**TOWN OF ABINGDON, VIRGINIA
HISTORIC PRESERVATION REVIEW BOARD
SPECIAL CALLED MEETING
WEDNESDAY, FEBRUARY 15, 2023 – 5:15 P.M.
COUNCIL CHAMBERS, MUNICIPAL BUILDING
CONTACT: GABRIEL CRISTOFARI**

SUBJECT: REQUEST FOR A CERTIFICATE OF APPROPRIATENESS FOR A REAR TWO-STORY FRAME ADDITION

ADDITION TO THE WEBB RESIDENCE

147 E. VALLEY ST ABINGDON VA 24210

View of North facing elevation for 147 E. Valley Street. Red rectangle showing proposed rear addition location

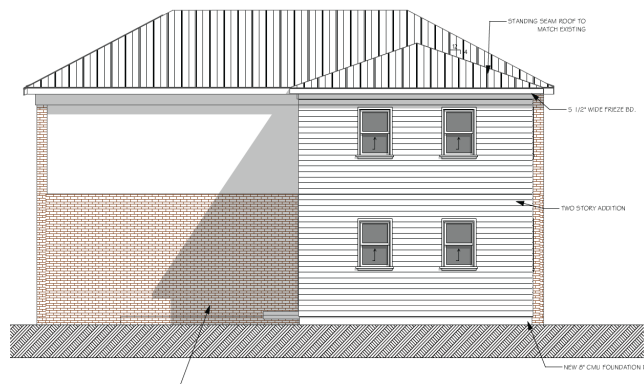
However, the addition will require the removal of three wooden windows located on the North elevation. Two of the three windows to be removed are double hung sash, the top sash is three-over-two and the bottom sash is one singular square pane. This type window configuration matches what is seen throughout the exterior of the existing structure. The third window located on the second floor level is a smaller window with a screen attached. The addition's proposed roof would connect into the existing roofline, altering the roofline. Overall, the proposed window openings will line up and match the existing window openings as seen on 2/7/2023. The existing window openings will be converted to transitional points between the existing structure and proposed rear addition.

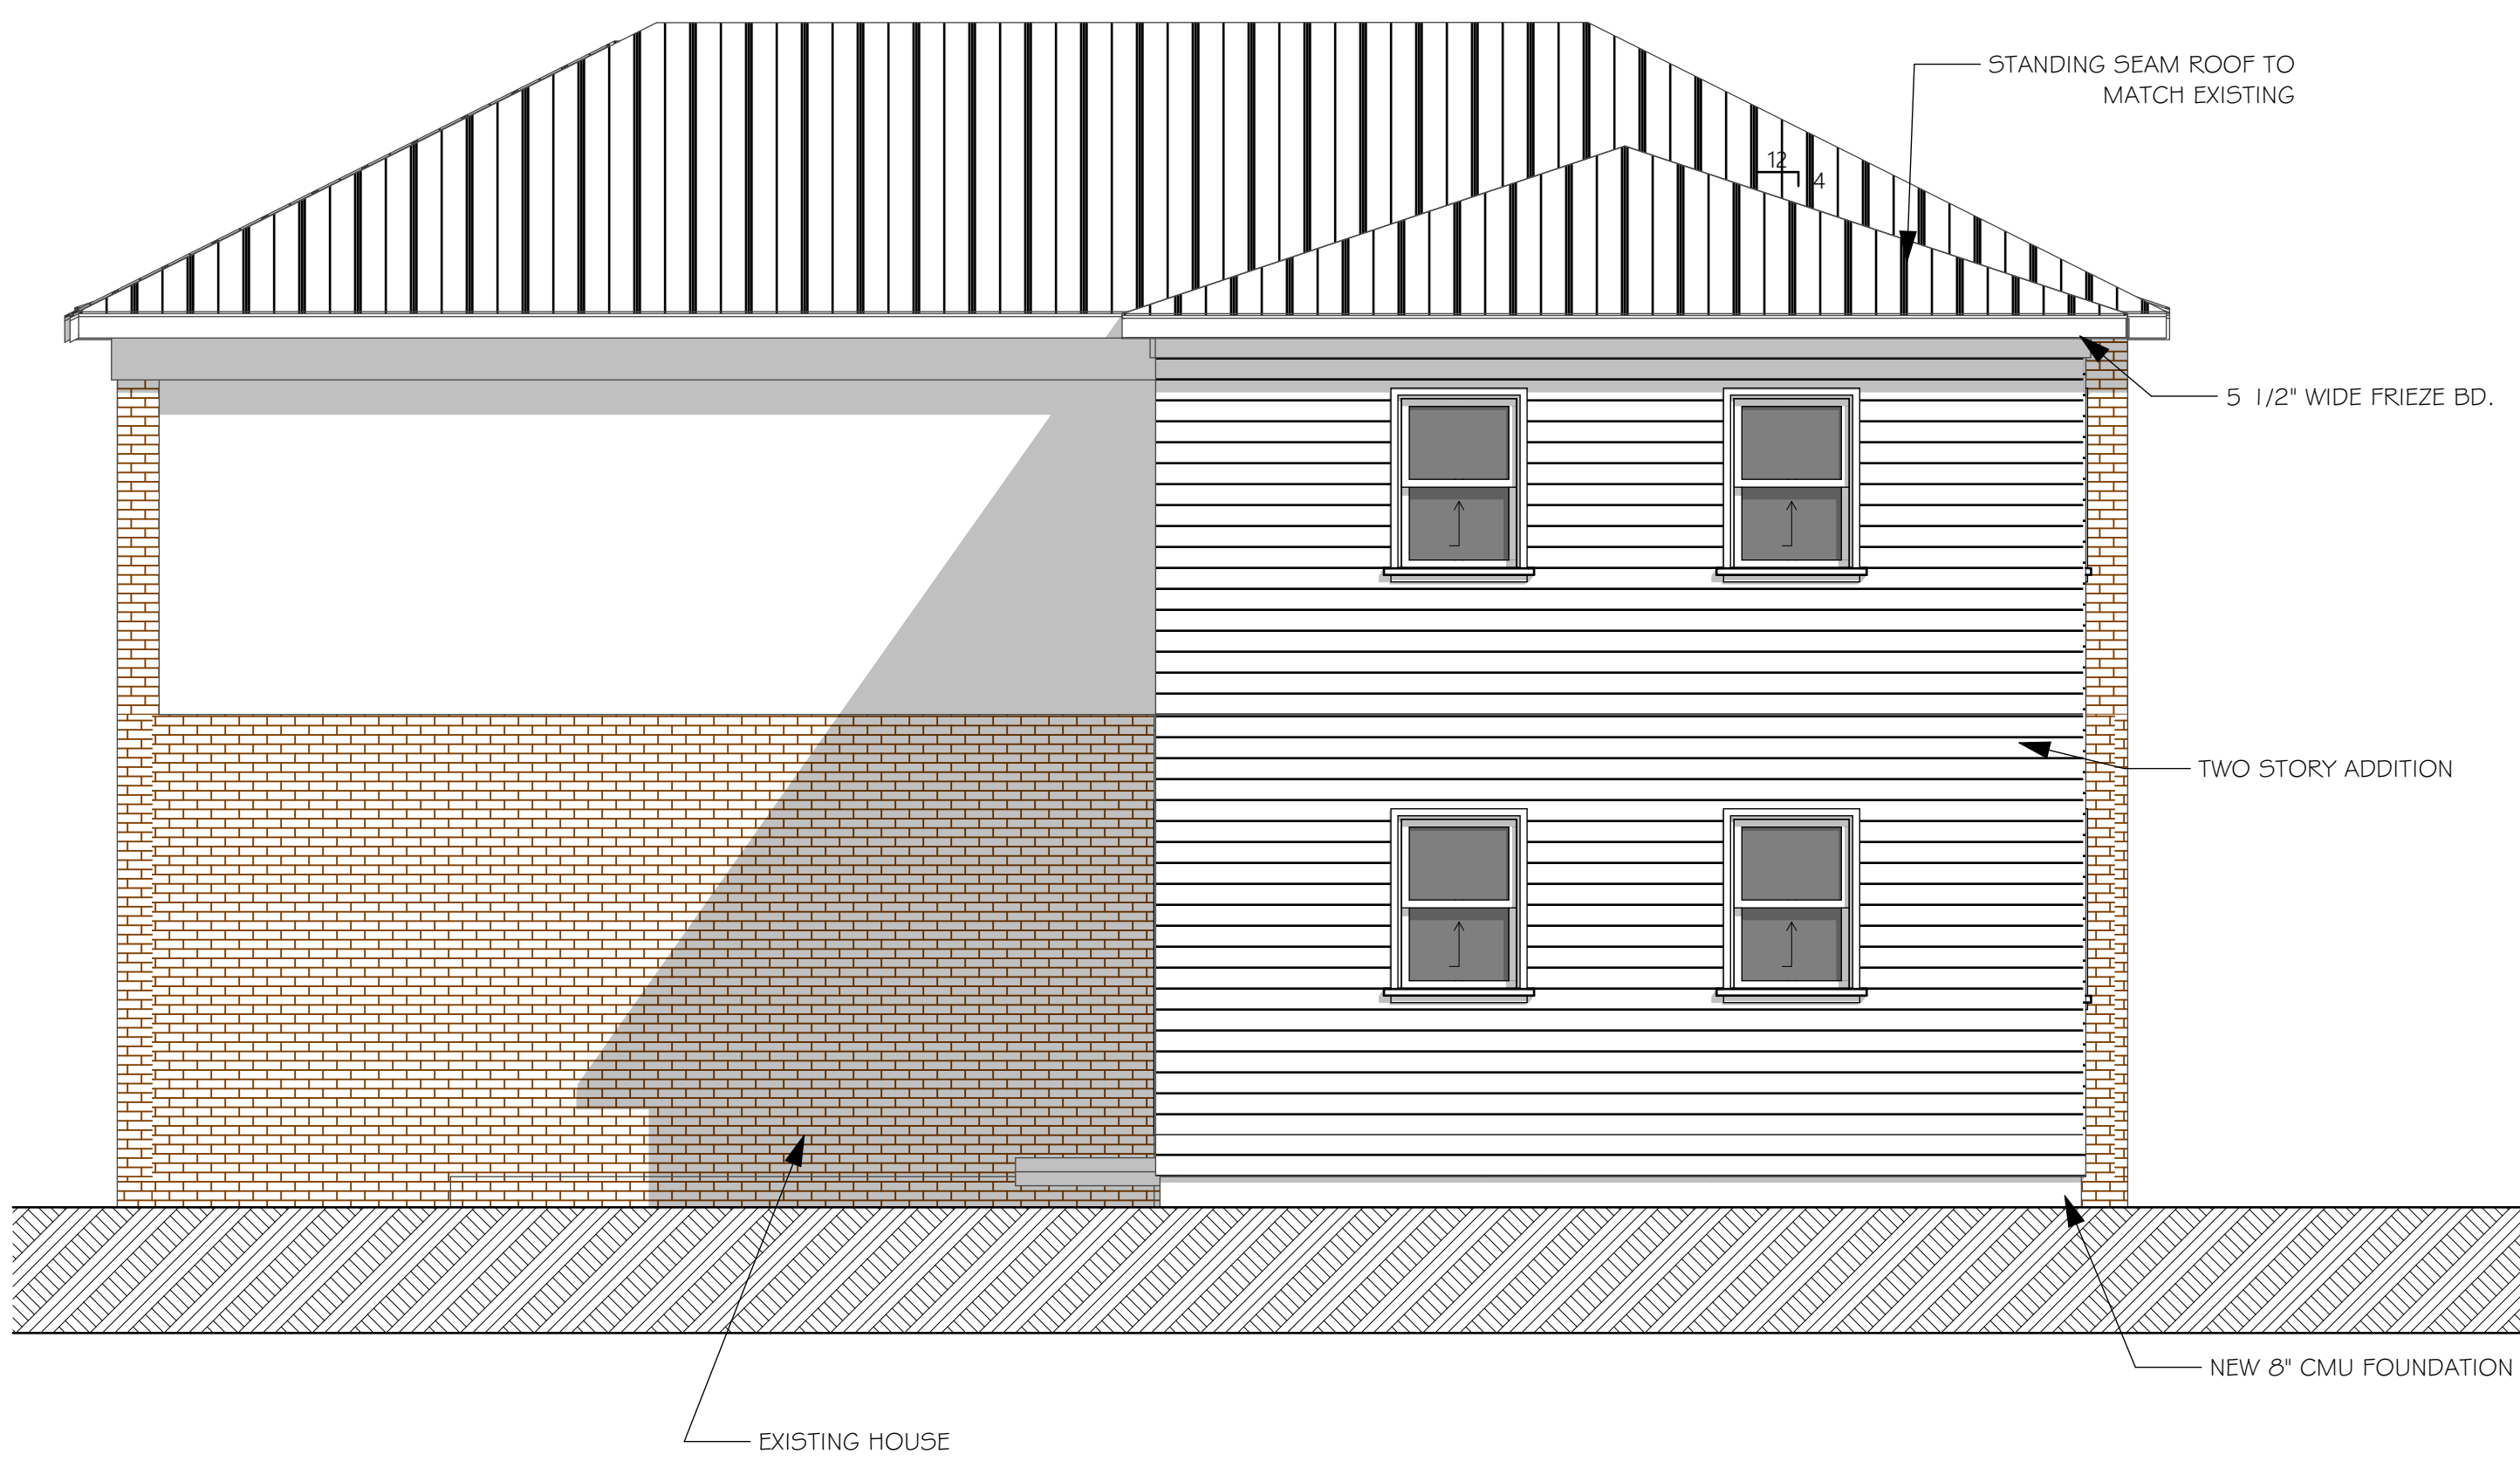
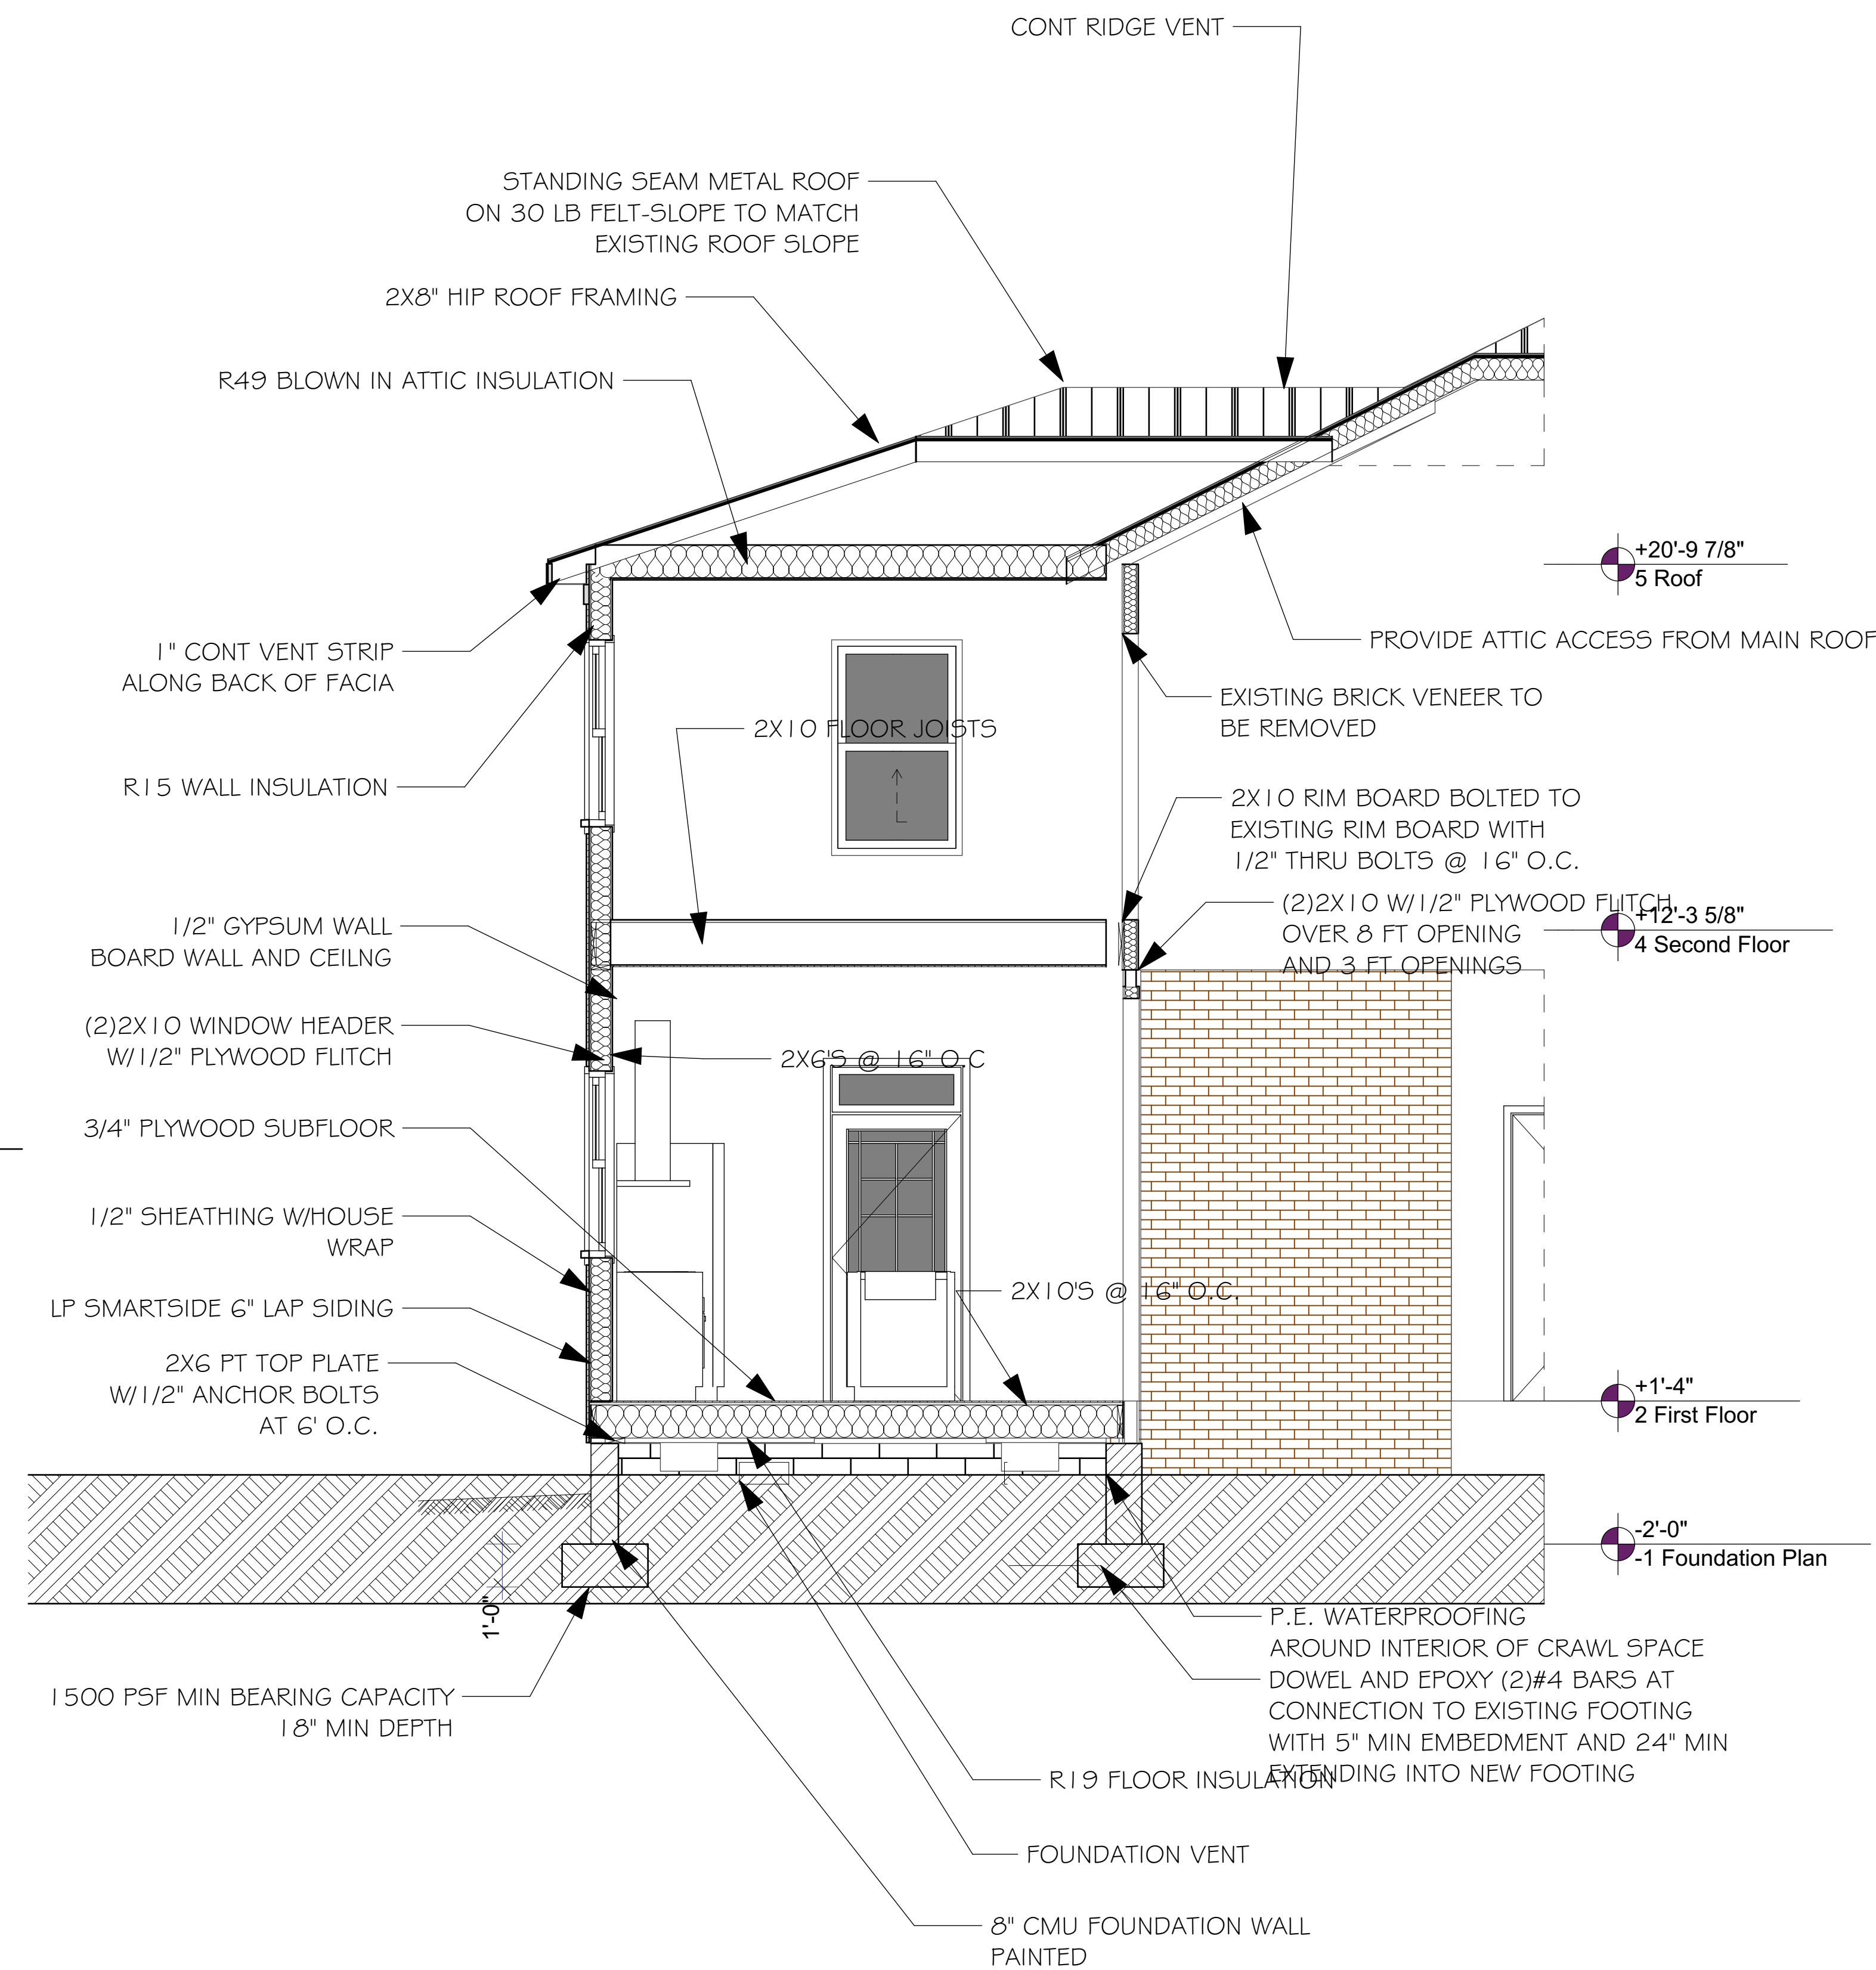
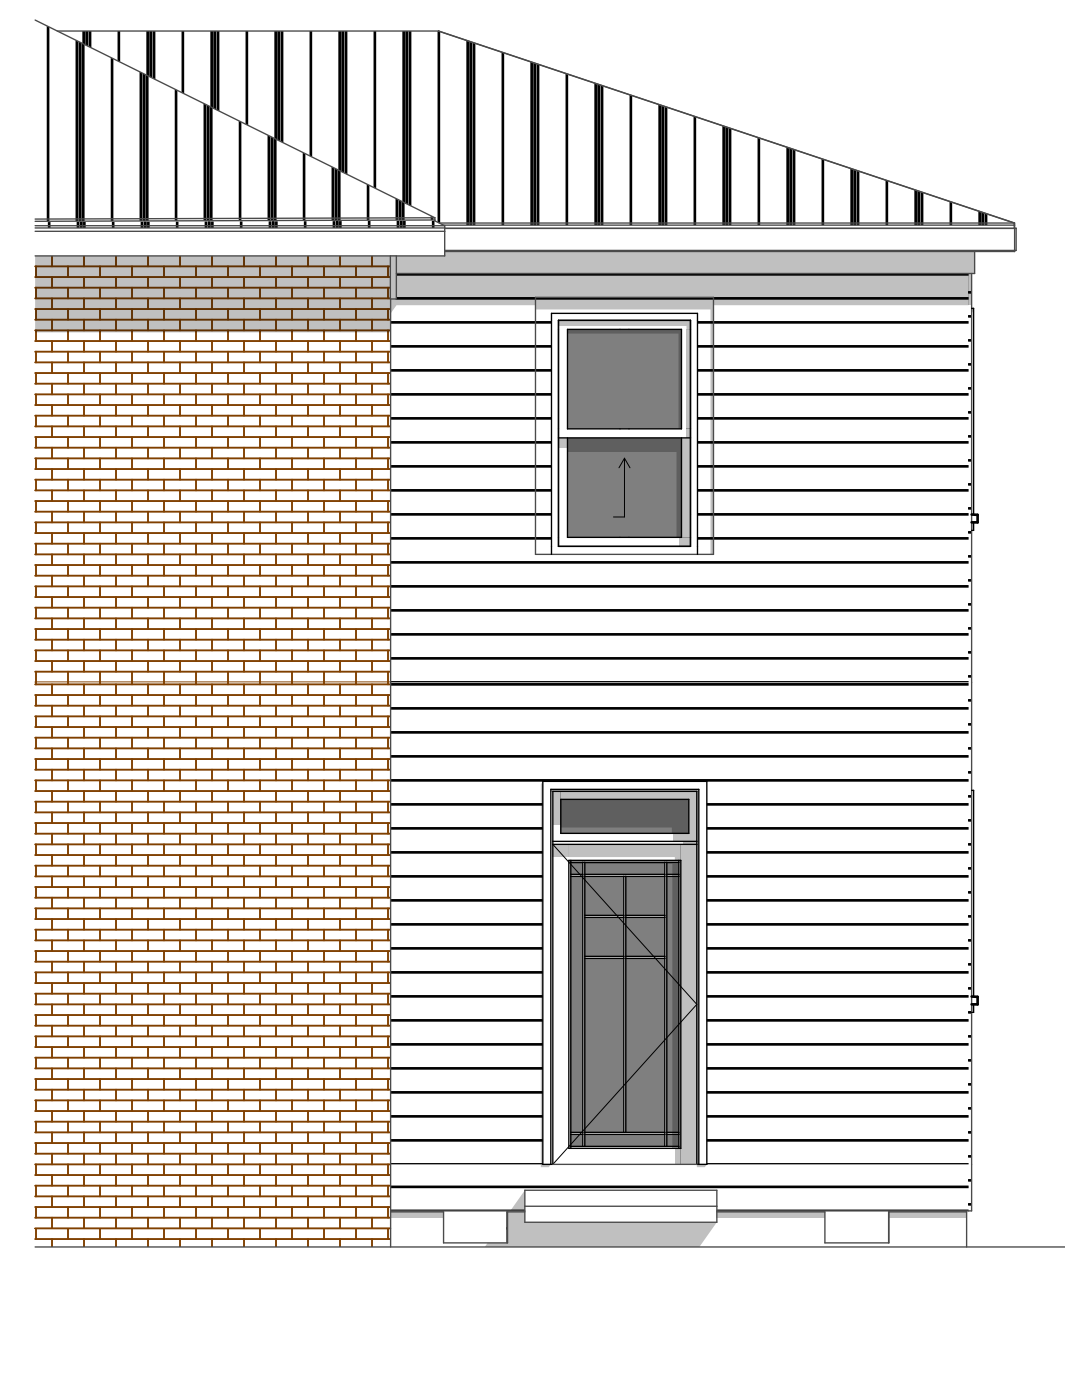
West Elevation: Three narrower one-over-one single hung sash windows will be centered on the first floor level, and a one-over-one single hung sash window will be centered on the second floor level directly above the first floor level window. The West elevation is the only visible elevation of the addition seen from a public right of way.

East Elevation: A modern door centered on the first floor level leading out into the back yard. A one-over-one single hung sash window centered on the second floor level directly above the modern door. A landing will be located directly outside the modern door. Staff has concluded based on site visits the East elevation cannot be seen from a public right of way.

North Elevation. Two one-over-one single hung sash windows will be evenly spaced on the first floor level, and two one-over-one single hung sash windows will be evenly spaced on the second floor level directly above the windows located on the first floor level. Staff has concluded based on site visits the North elevation cannot be seen from a public right of way.

Foundation for the two-story rear addition will consist of 8 in. exposed CMU. According to the Design Review Guidelines, exposed CMU is not appropriate but should be finished with stucco or other finishes providing a textured surface.

Additionally wood construction is preferred for windows, the use of vinyl clad or aluminum-clad windows is acceptable so long as their dimensions are compatible with historic window openings.
